Cle Elum Improvements Project  
Final Cost Estimate  
April 2000

Final Cost Estimate - CLIP  
Cle Elum Improvements Project  
a.k.a. 3' Pool Raise Project  
April 2000

**Cle Elum Improvements Project (CLIP) Cost Estimate Summary Report**  
**(\$16,687,100 plus Fish Passage Costs, or \$26,687,100 to \$51,687,100)**  
**April 11, 2000**

U.S.BUREAU OF RECLAMATION	CLE ELUM DAM
up	FISH PASSAGE STUDY
DOWNSTREAM PASSAGE	
CONCEPT #5	
Scale: 1" = 200'	
Date: SEPTEMBER, 1999	
File:	
Drawing 8	
HARZA Engineering Co.	BELLEVUE, WASHINGTON (425) 602-4000

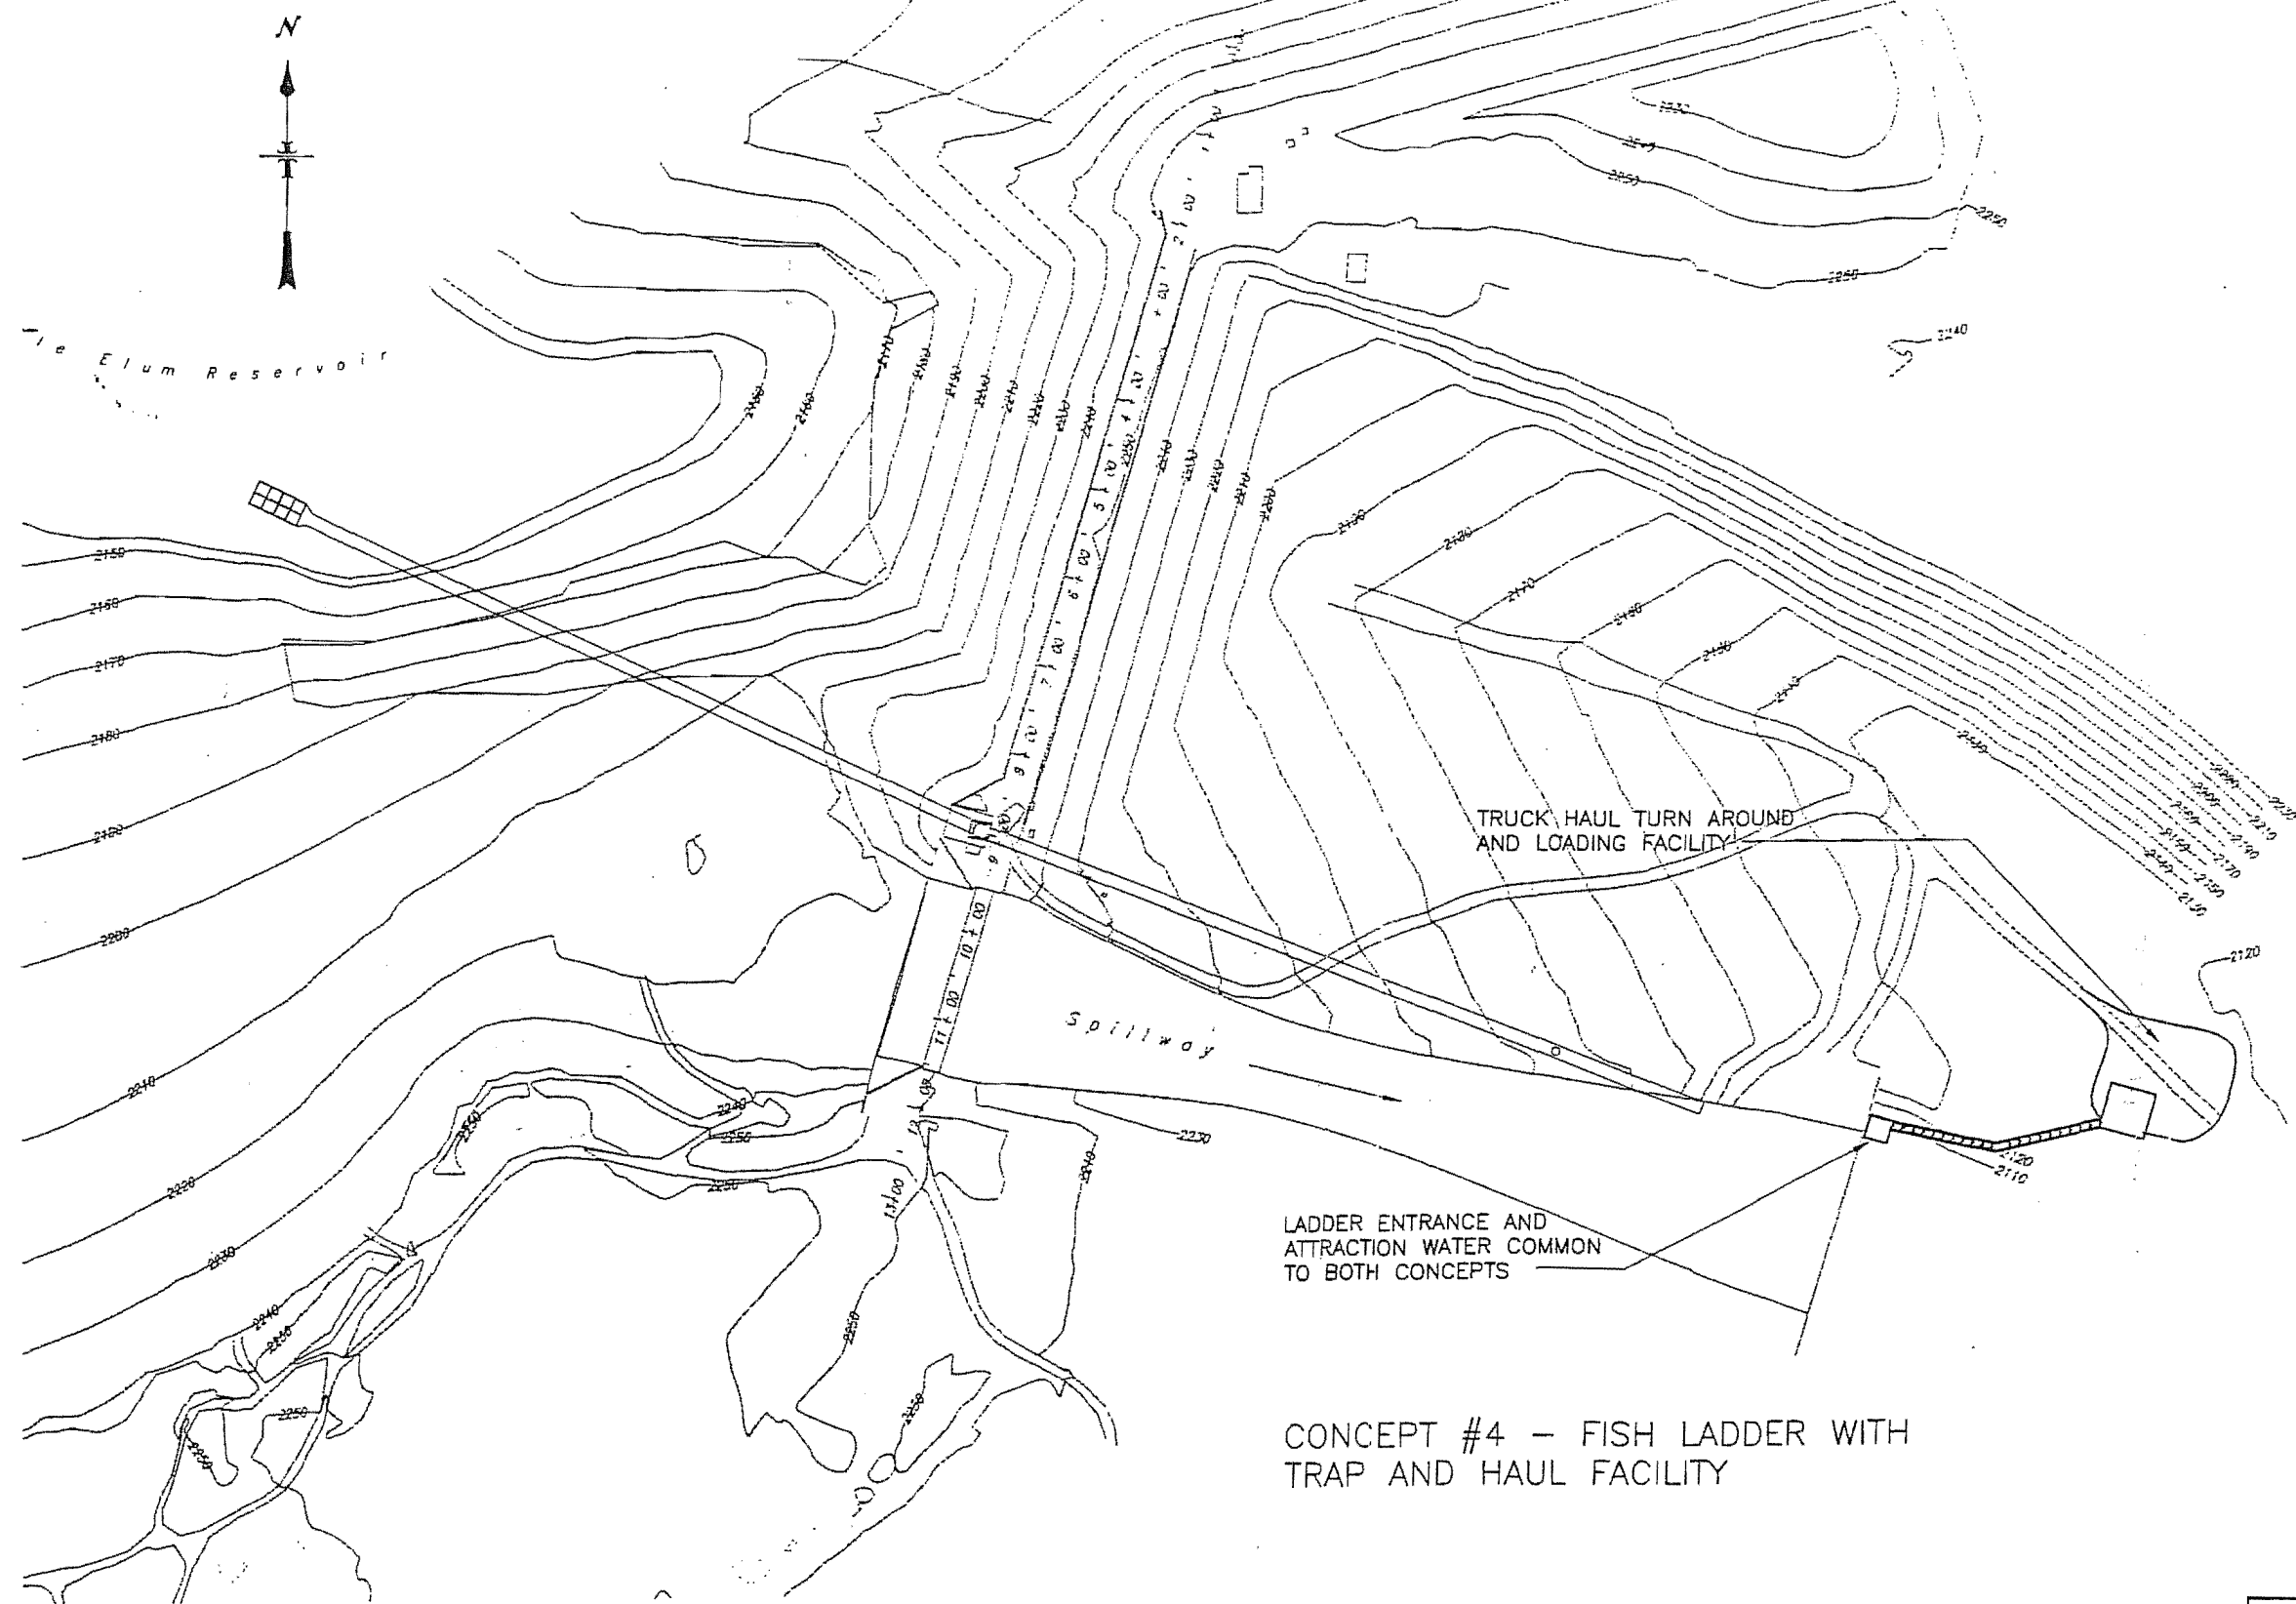
Upstream concept #5 shows a long fish slide, it might be a bit stressful on the fish. Would the fish hit a sheet of ice? Rather than
